Document No. : DSSNK-2601-B0-1

Notification of Polarizer on LCD Panel to PFAS-free

Product Name: TCG058WXLBPVNN-AN30

〈Schematic diagram〉
(for reference)

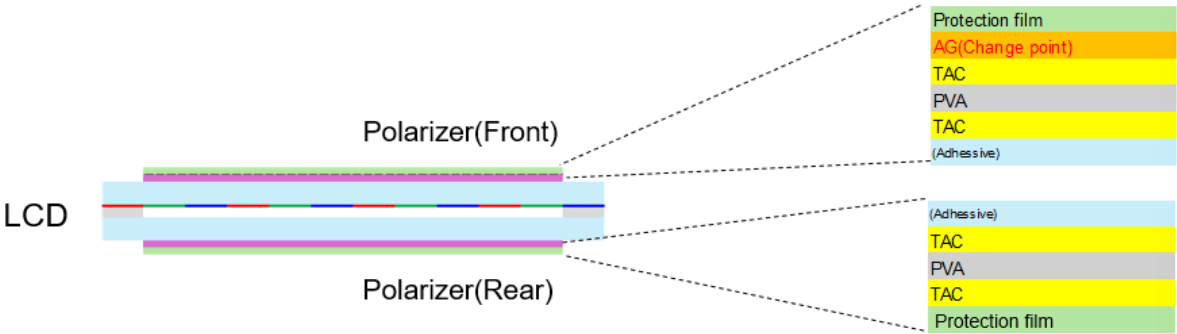
We would like to inform your company that we have received an application from the polarizer supplier for a component change, which is aimed at reducing environmental impact, complying with future legal regulations, and ensuring supply continuity.

Applicable Component: Polarizer

* Photo shown: 12.1" panel.

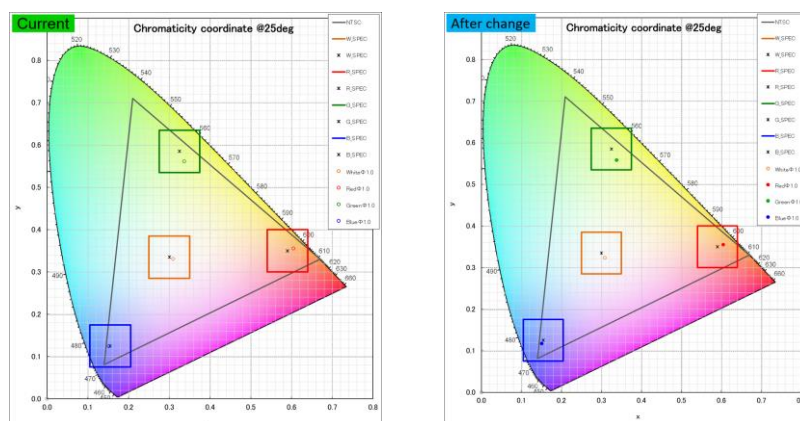
Item	Current	After change	Comment
AG (anti-glare) material	Contains PFAS	PFAS-free	Front polarizer
Appearance Difference			Same appearance as the current model.

Item	Change (Yes/No)	Comment	Note
Appearance	No	Please refer to the photo above.	
Optical Performance	No	Please refer below.	※
Reliability	No	Please refer below.	※
Specification Document	No	There will be no change in product name or revision of the specification sheet.
